# Foretravel

## SERVICE BULLETIN

**Subject: NHTSA Recall-Villa Seat Belt Bolt Replacement**

**Bulletin Number: R04V040**

\* BELT BUCKLE \*

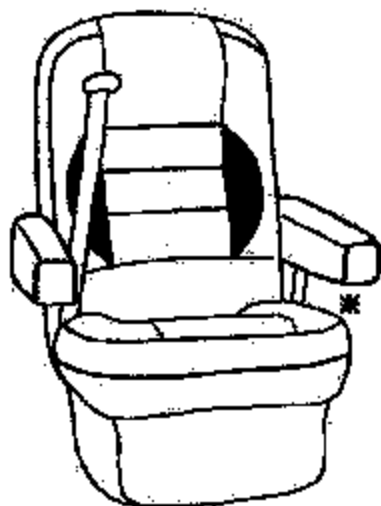
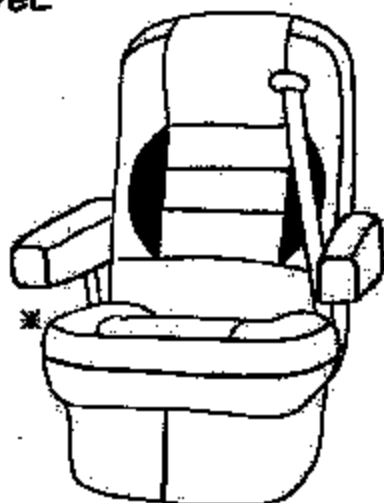
Villa International of Anaheim, California has initiated a NHTSA Recall on the driver and passenger seats on 60, 2004 year model U270, U295 and U320 (**Unit # Range 6234-6295**) Foretravel motor homes due to possible failure of the seat belt buckle bolt used to attach the buckle to the frame.

The recall will consist of removing the seat belt buckle bolt on both the driver and passenger seats. A bushing will be placed on the grade 5 bolt used to attach the seat belt buckle to the frame.

1. LOCATE BELT BUCKLE, I.E. RIGHT SIDE OF THE VEHICLE, SEE ABOVE FIGURES. BELT BUCKLE LOCATION INDICATED BY AN ASTERISK (\*).
2. TAKE OUT THE CAP AND LOOSEN EXISTING BOLT TO REMOVE BELT BUCKLE, SEE FIG. 1.
3. INSERT 7/8 ID x 3/8 OD x 3/4 SPACER INTO 1" DIA. TUBE; SEE FIG. 2.
4. RE-INSTALL BELT BUCKLE, WITH 3/8 USS FLAT WASHER ZINC & 3/8-16 x 2 GRADE 5 HEX BOLT. SEE FIG. 2.
5. TIGHTEN BOLT TO 30 FT. LBS. PUT CAP BACK ON.
